PROJECT ID NO. SWQ0000005

**MONTEITH PARK AND VIEW PARK
GREEN ALLEY STORMWATER IMPROVEMENTS**

NOTICE INVITING BIDS

TREATMENT SPECIFICATIONS

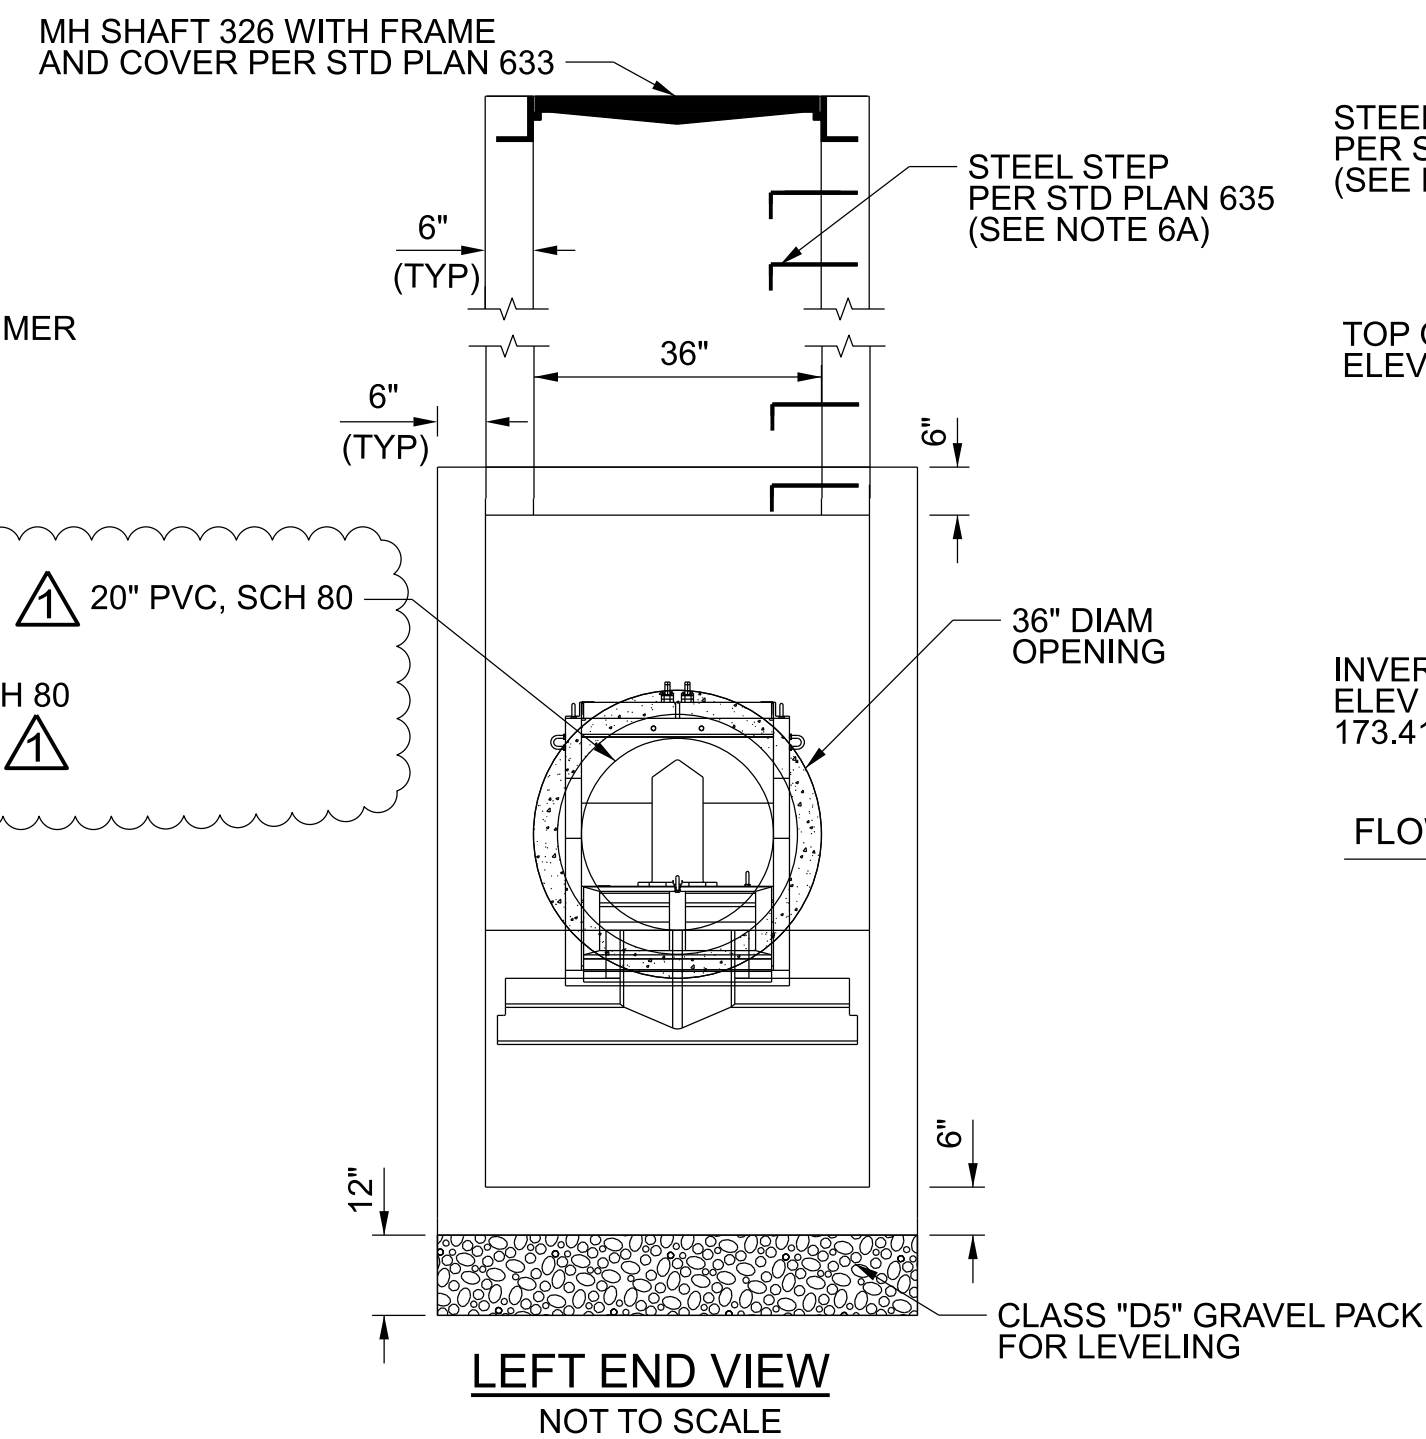
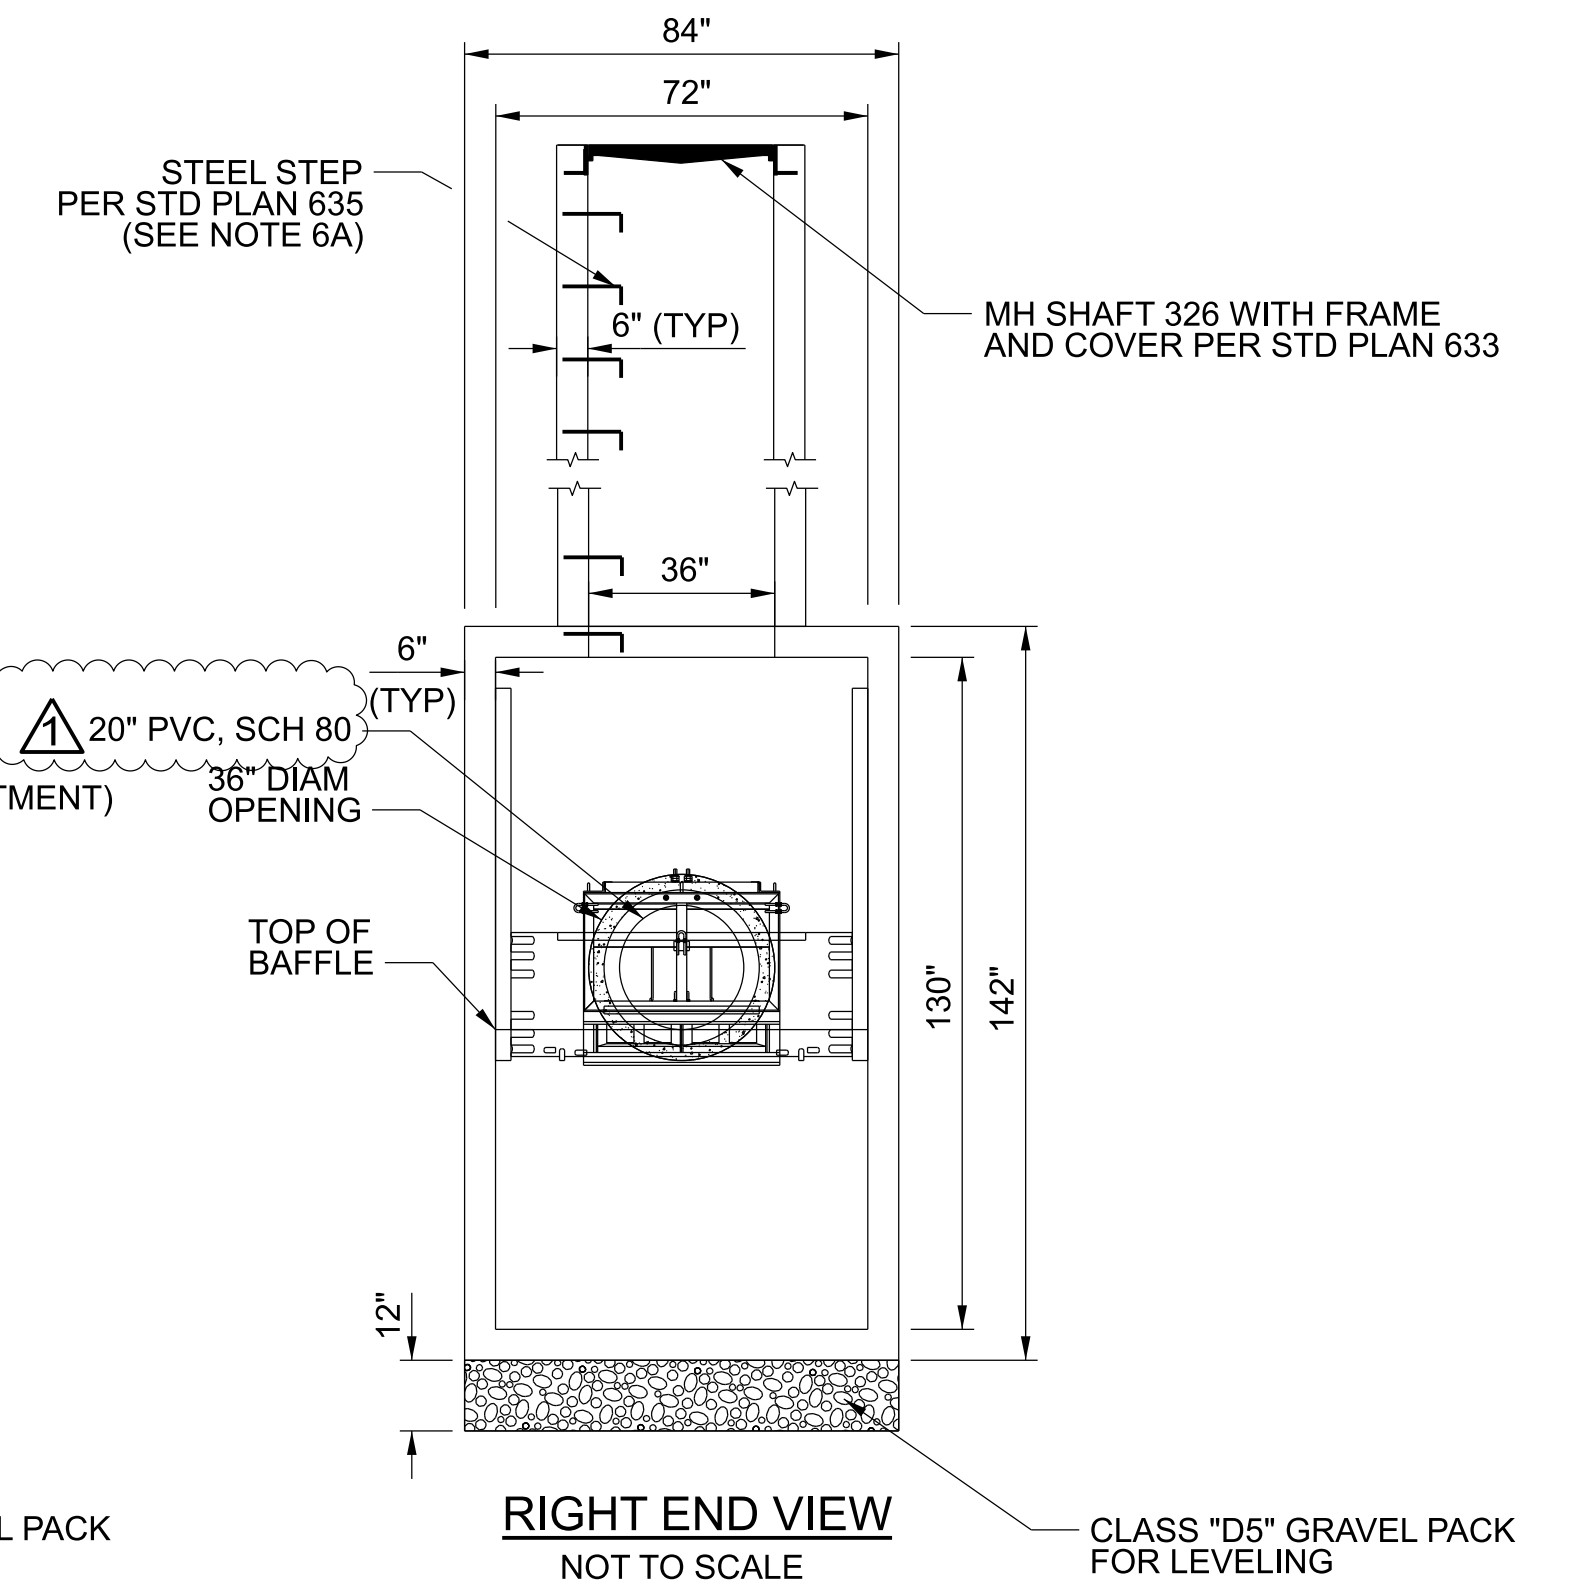
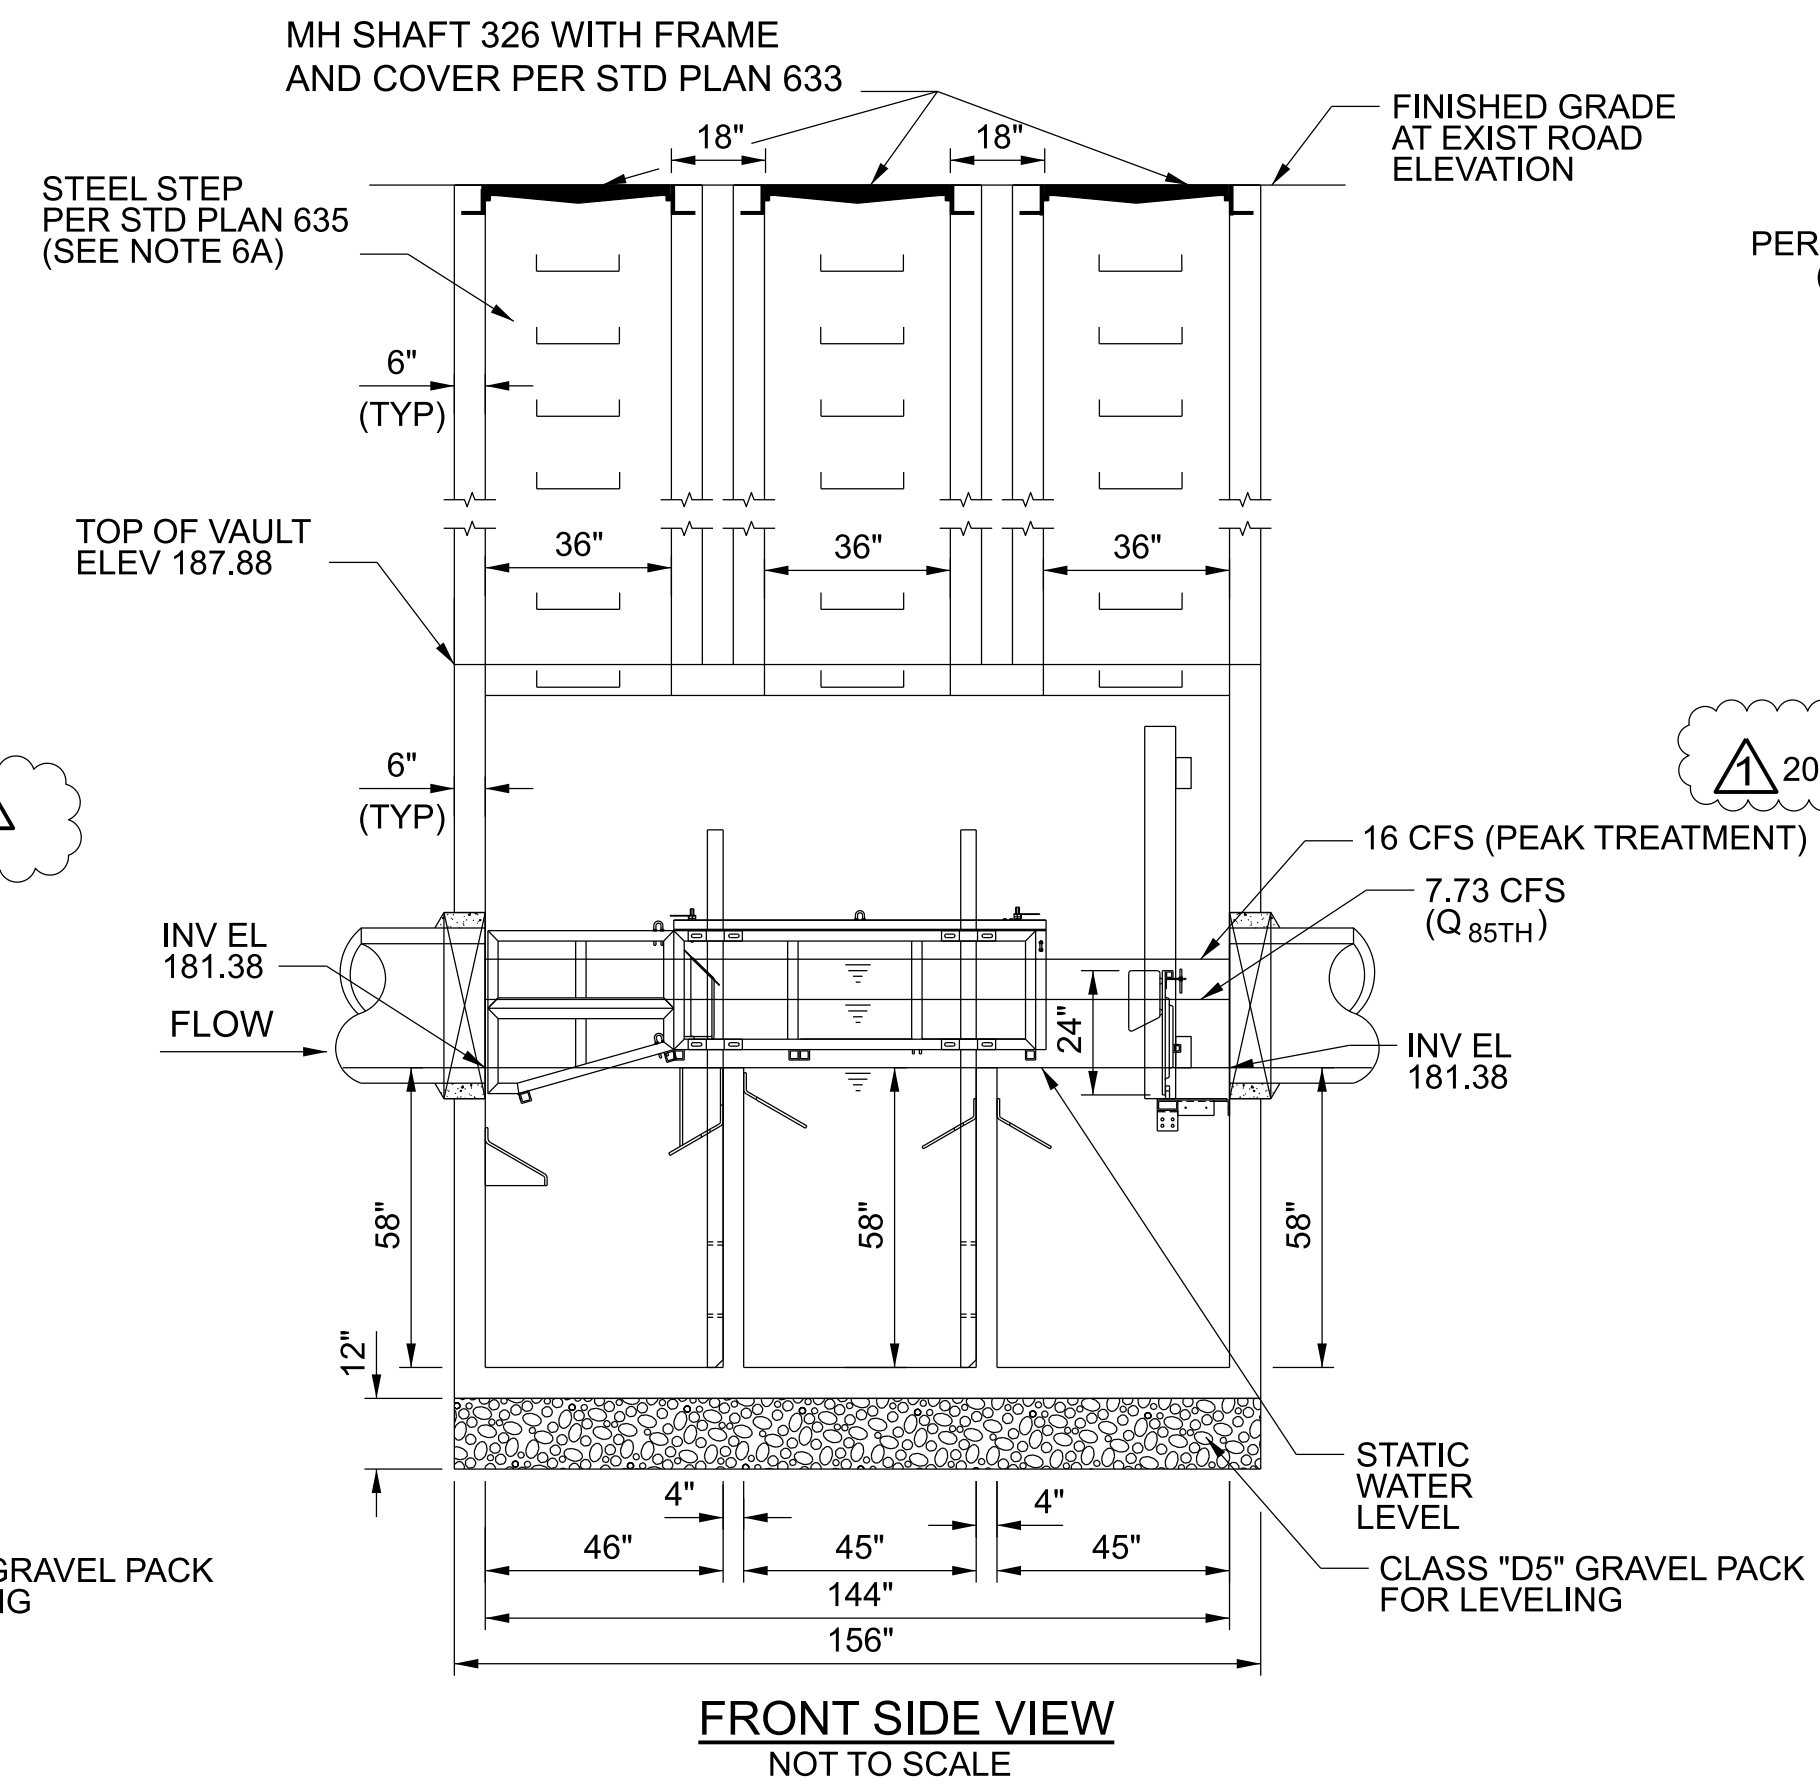
DATE	MK	DESCRIPTION
11/17/22	N. L.	CHANGED INFLOW AND OUTFLOW PIPE FROM 24" RCP TO 20" PVC

A64. All pipes going in and out of all 3 the filtration units shall be 20" PVC SCH 80. Refer to the revised Plan sheets included with this Addendum No. 2.
